塑钢门合页技术改进说明

Technical Improvement of uPVC Door Hinge

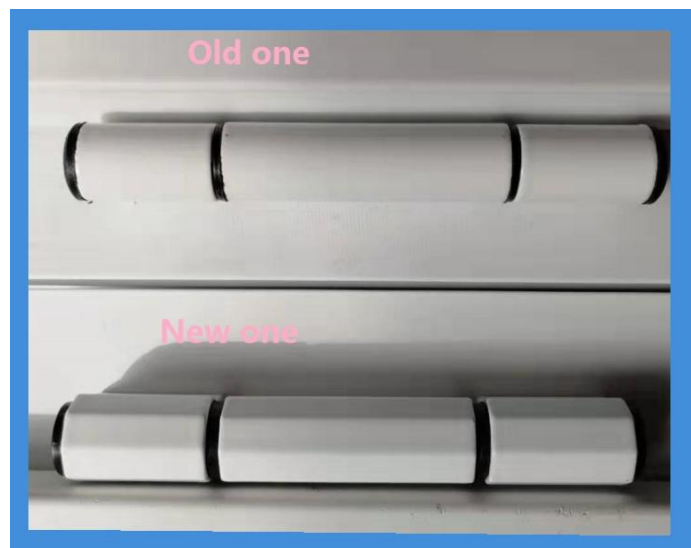
新款合页相较于老款合页，无论在结构还是性能上面都有很大的提升。
Compared with the old hinges, the new hinges have a great improvement in both structure and performance.

(1) 新款外轴为方轴，看起来更美观

The new model axis is square shaped, looks better in appearance

Thickness of the shaft cover:

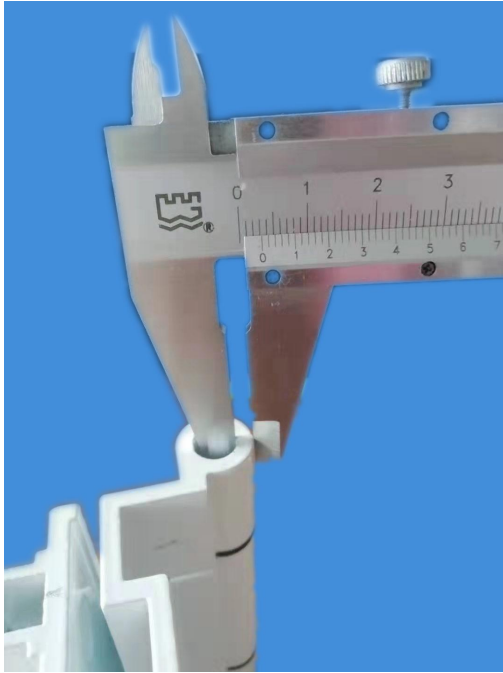
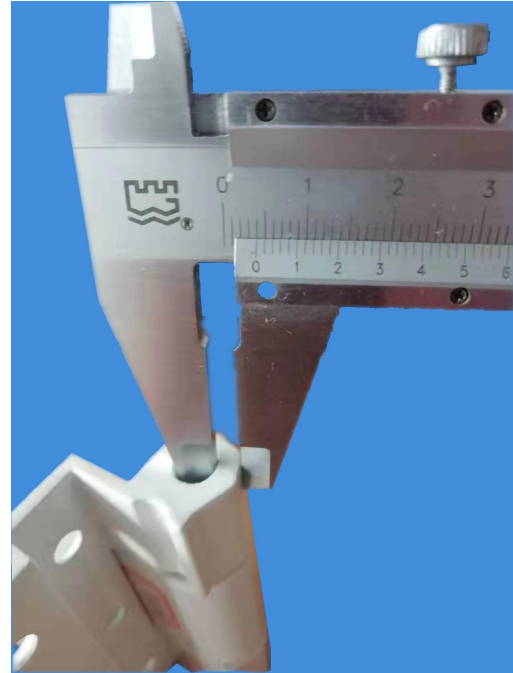
1、轴的壁厚加厚

The Old one T=3mm

The New one T=4mm

Thickness of the frame leaf

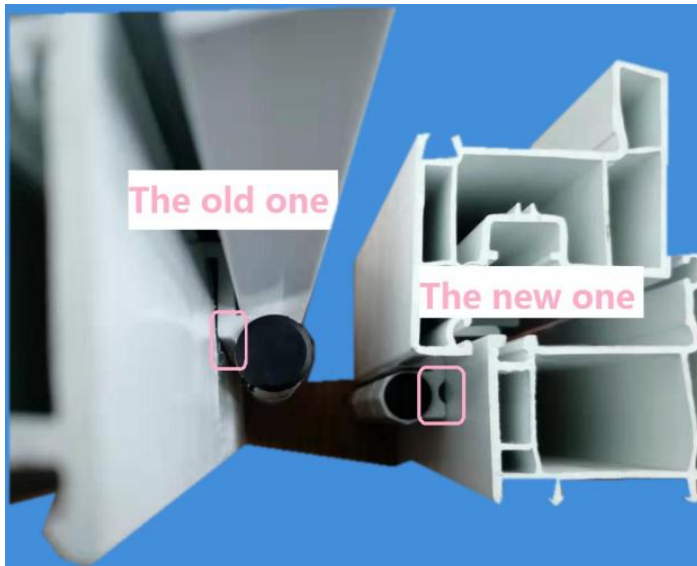
2、装在框上的壁厚加厚

Old one

New one
